**To:** Members of Dublin City Council  
**From:** Dana L. McDaniel, City Manager */mgl/dm*  
**Date:** March 16, 2017  
**Initiated By:** Vincent A. Papsidero, FAICP, Planning Director  
Jennifer M. Rauch, AICP, Planning Manager  
**Re:** Basic Plan – Parking Garage – (Case#17-003ARB-BPR)

17-003ARB/BPR  
Basic Plan Review  
Columbus Metropolitan Library - Garage  
75 N. High Street

CITY OF DUBLIN, FRANKLIN COUNTY, OHIO  
BASIC SITE PLAN  
FOR  
CITY OF DUBLIN  
PARKING GARAGE  
2017

CITY OF DUBLIN, FRANKLIN COUNTY, OHIO  
BASIC SITE PLAN  
FOR  
**CITY OF DUBLIN  
PARKING GARAGE  
OVERALL SITE PLAN**

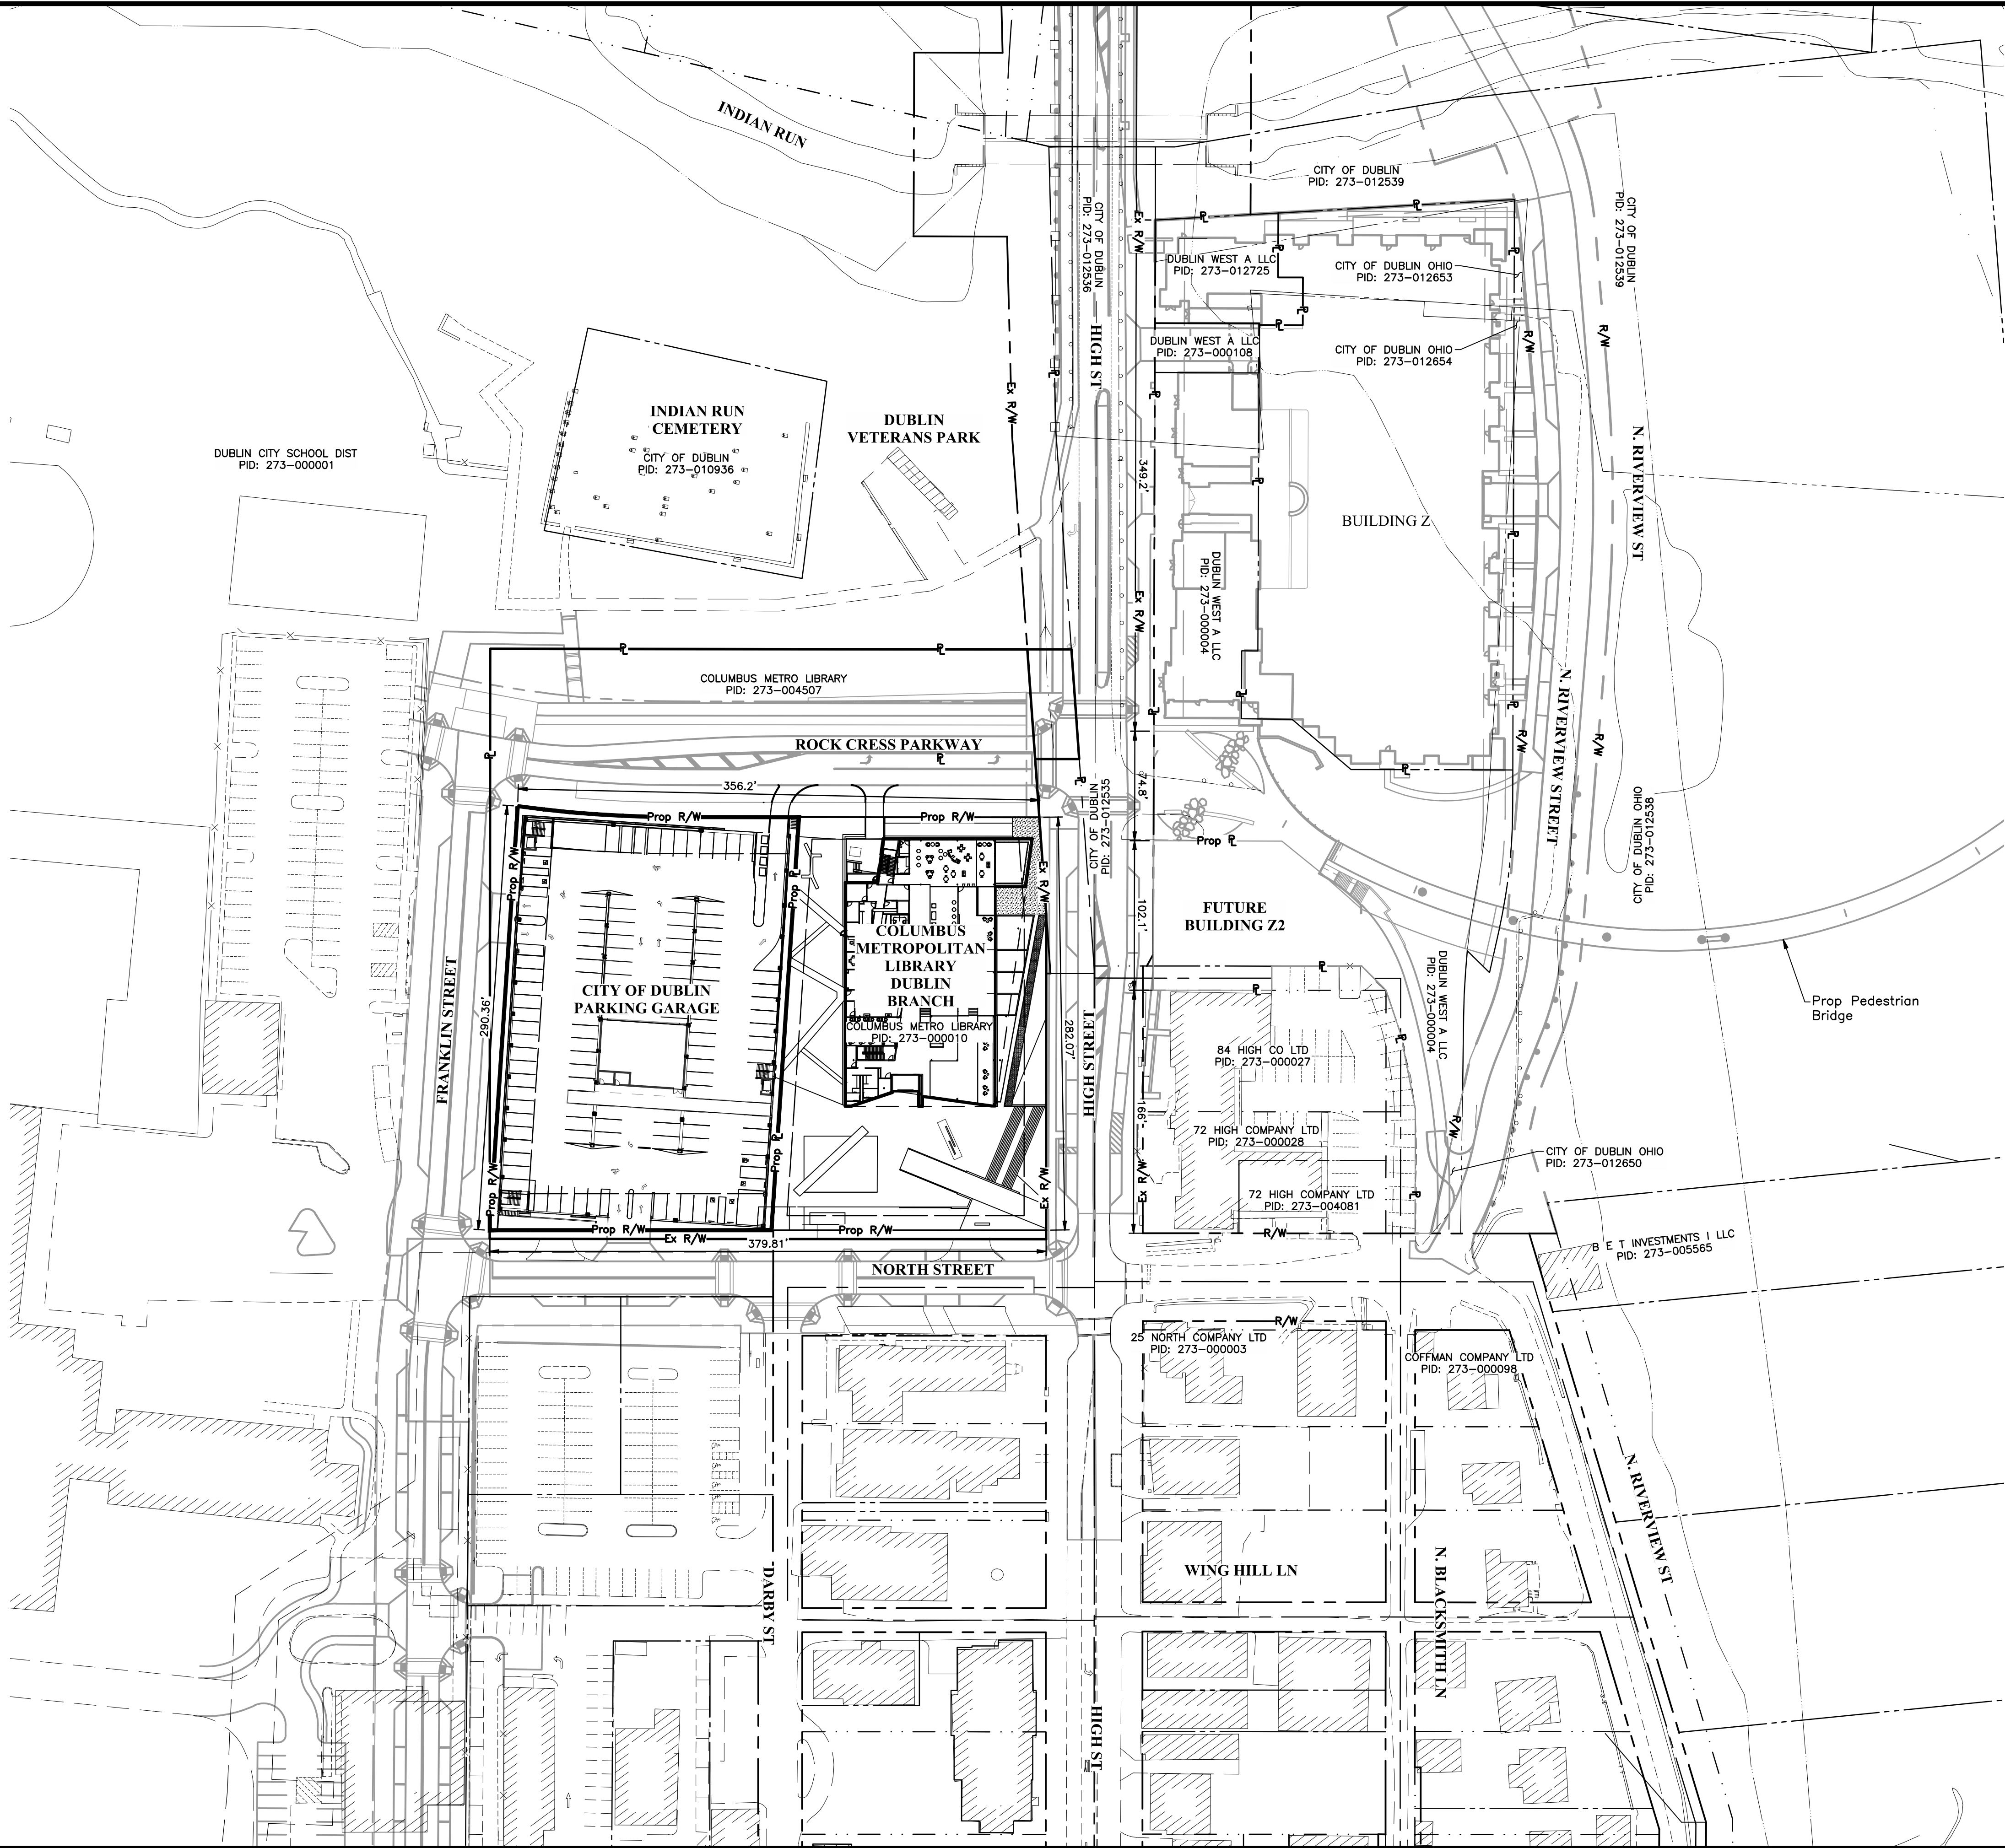
Ms. Rauch pointed out the bike hub and book drop on the north elevation. Aaron Stanford asked for a condition of approval to be added regarding tightening the turning radius from the book drop exit to limit the movement to right out only.

Aaron Stanford questioned the difficulty in maneuverability for the spaces directly across the entrance on North Street by the pedestrian passage. He also asked about the width of the drive by the book drop as it appears to be only 20.8 feet across and 22 or so is required. Ms. Rauch suggested that possibly the size of the island could be decreased to provide more width for that drive aisle. She also suggested another look at the parking spaces at the entrance with the subsequent elevations.

**EAST ELEVATION**  
**North High Street**

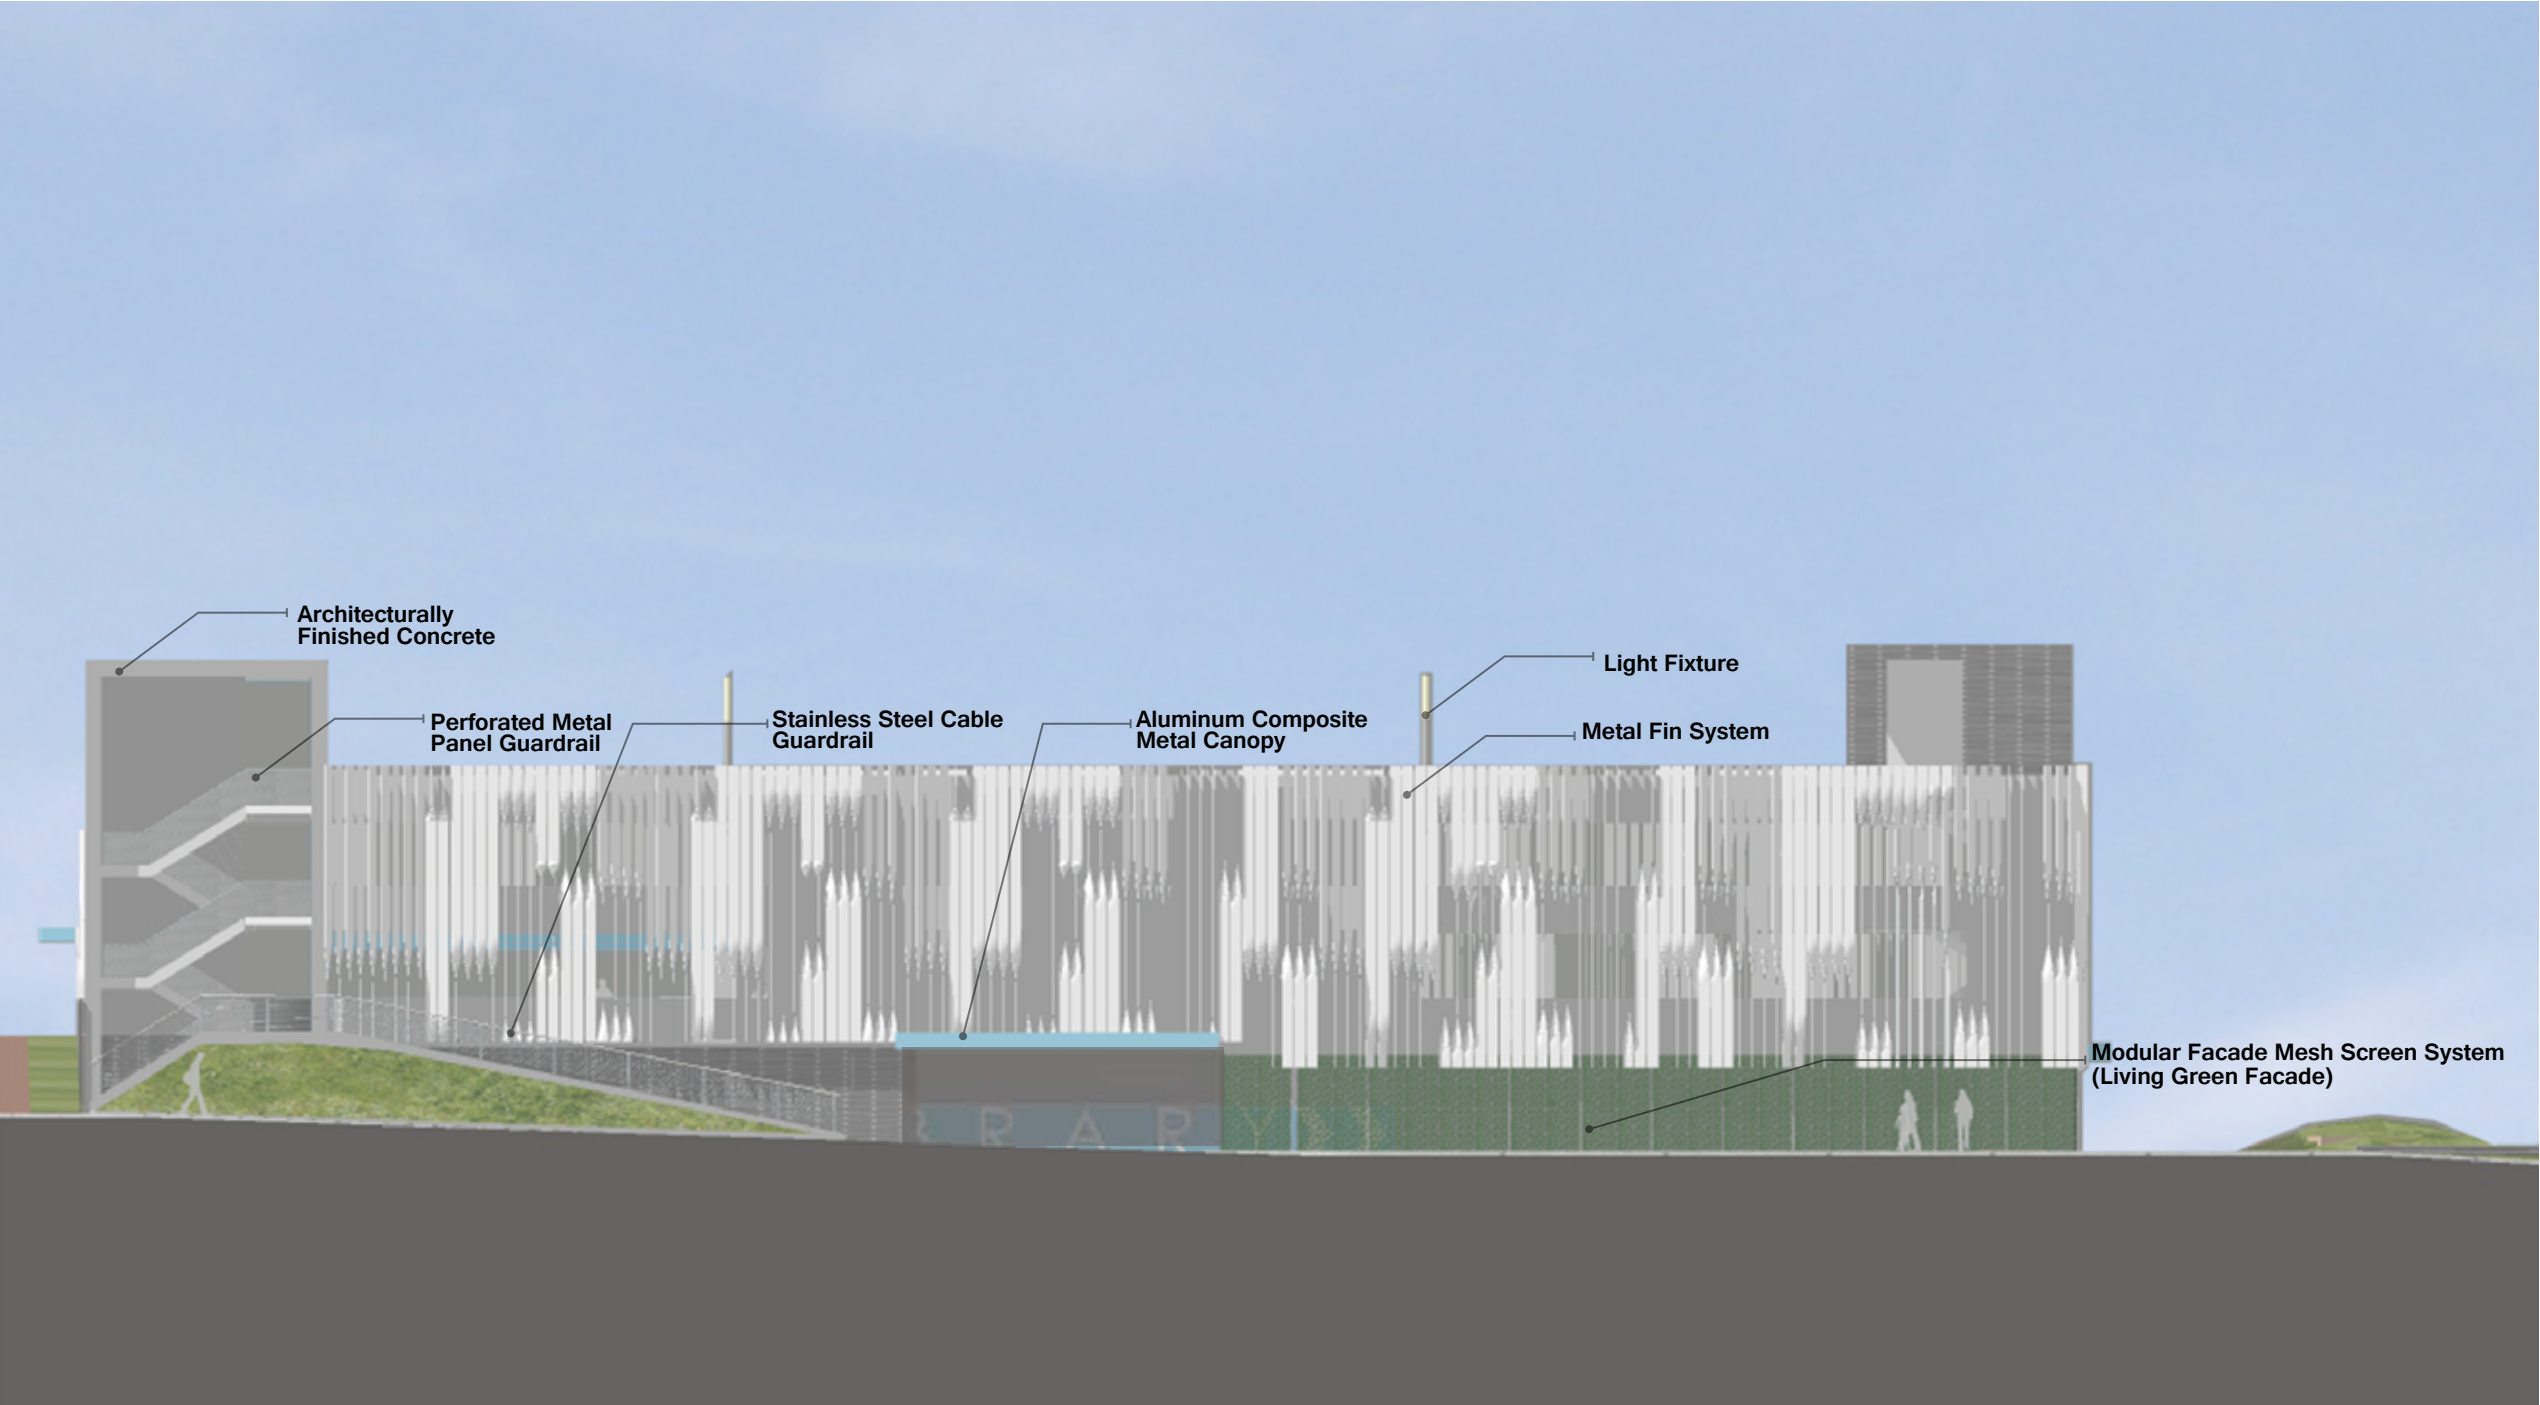
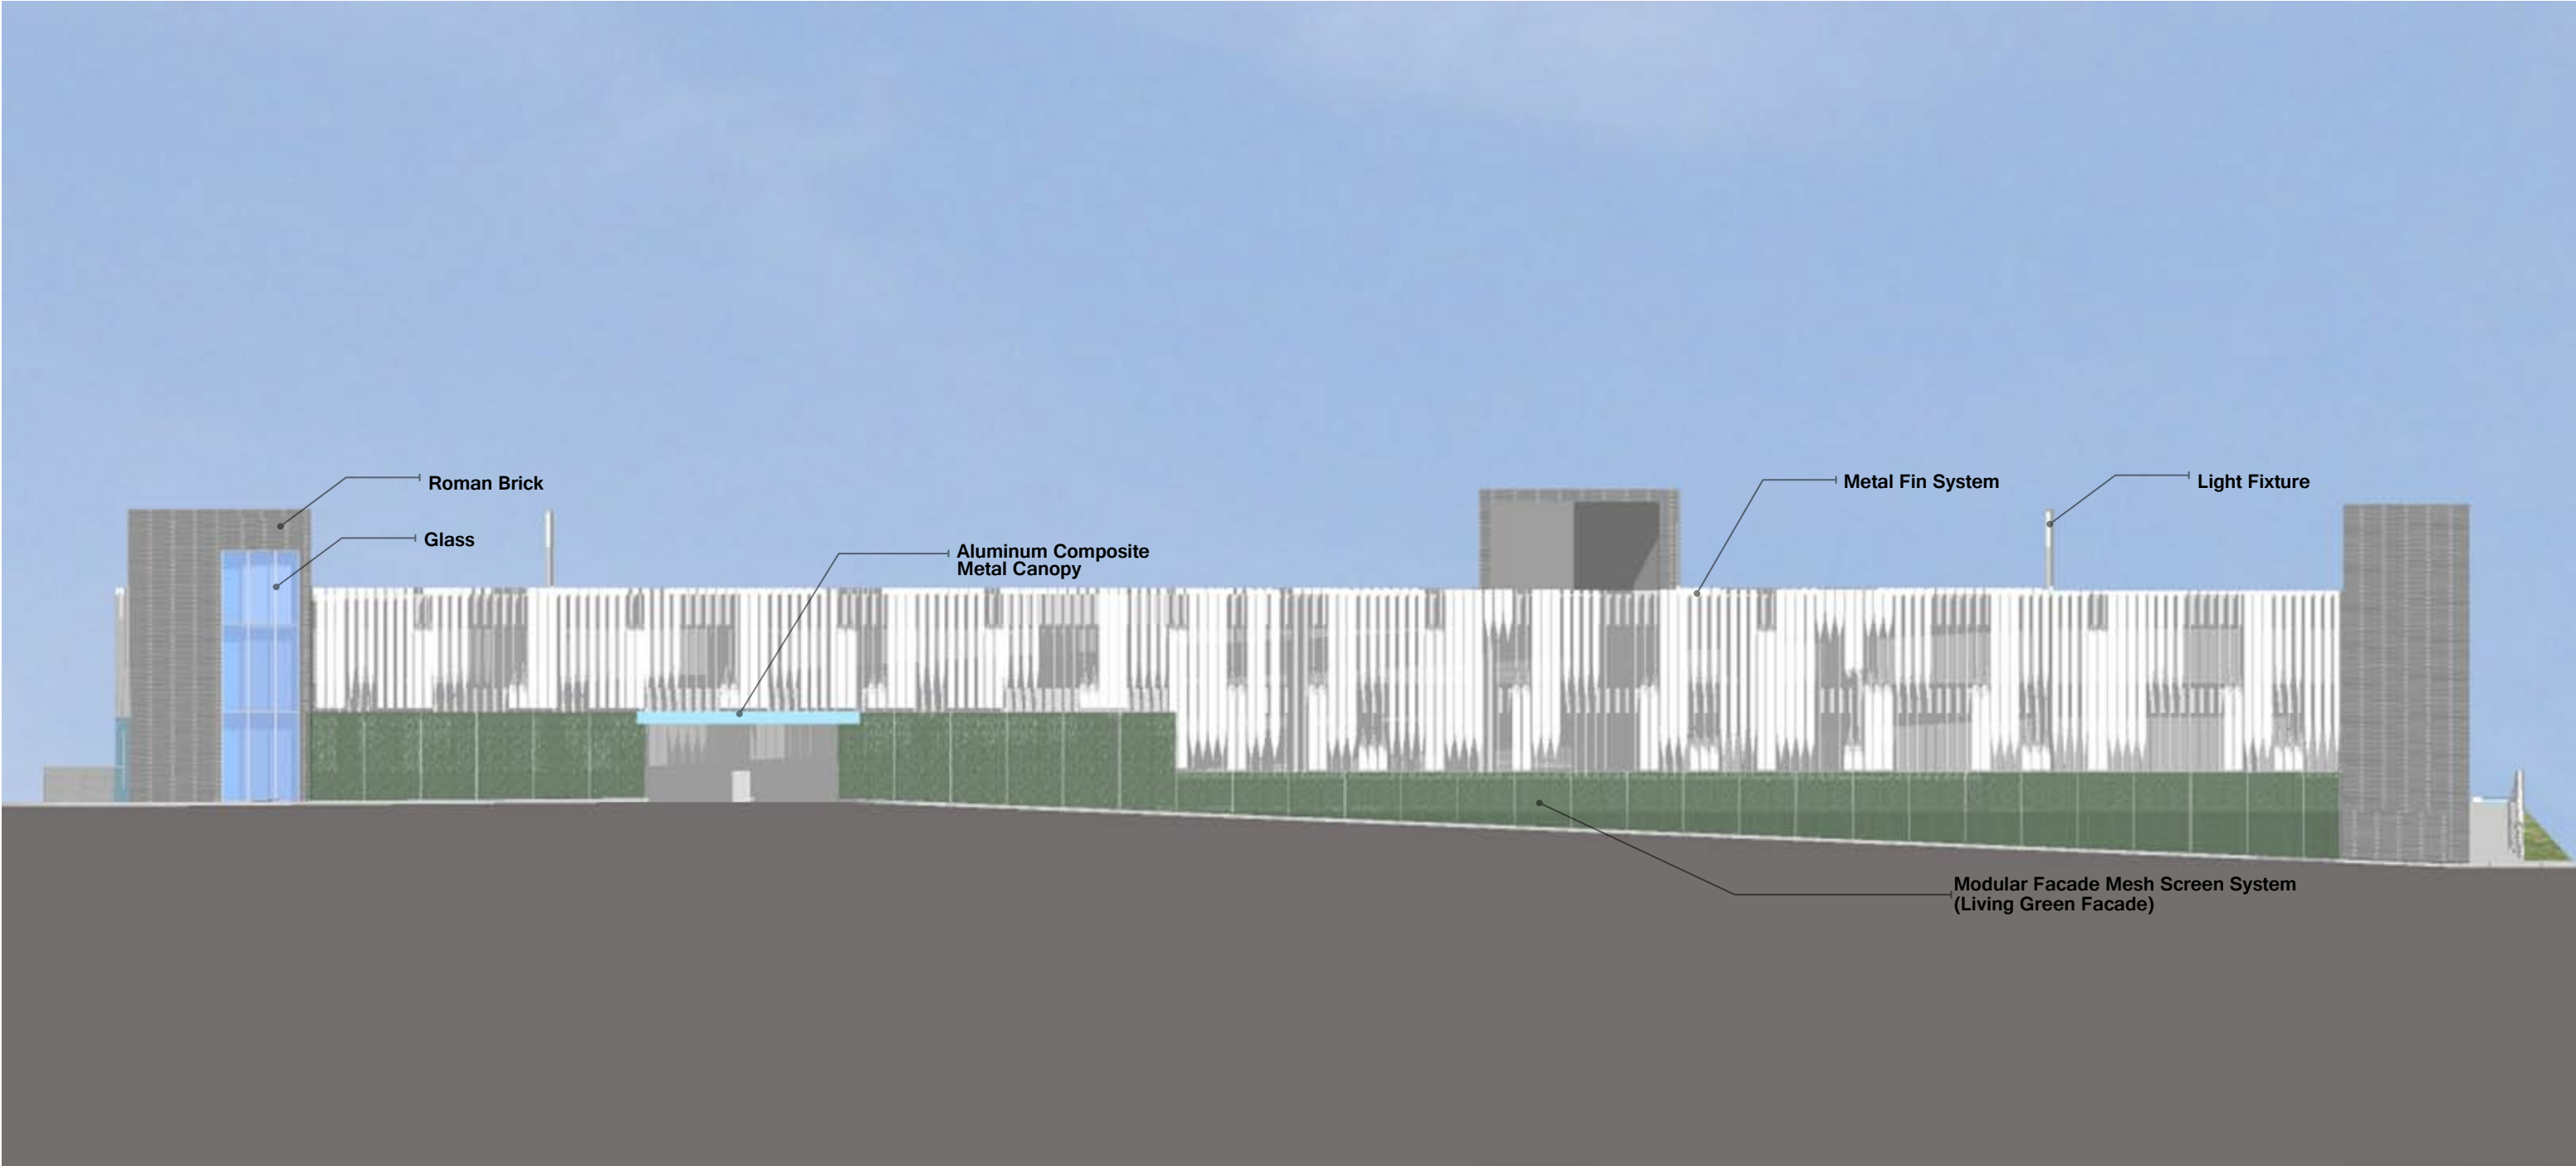
4. §153.063(D)(4)(b): Building Height – Building height limited to 2.5 stories adjacent to the Historic Core District (required); 3 stories at the north, east, and south elevations (requested).

5. §153.062(O)(12)(b): Story Height – Ground Story minimum and minimum clearance is 12 feet (required): 11 feet (requested).
6. §153.065(B)(5)(c): Story Height – Minimum clearance is 12 feet (required): 11 feet (requested).

Ms. Rauch added the proposal requires a Waiver for the ground story height at Rock Cress Parkway because the Code requires 12 feet and the proposal indicates 11 feet. The proposal meets story height requirements on the remaining elevations she said.
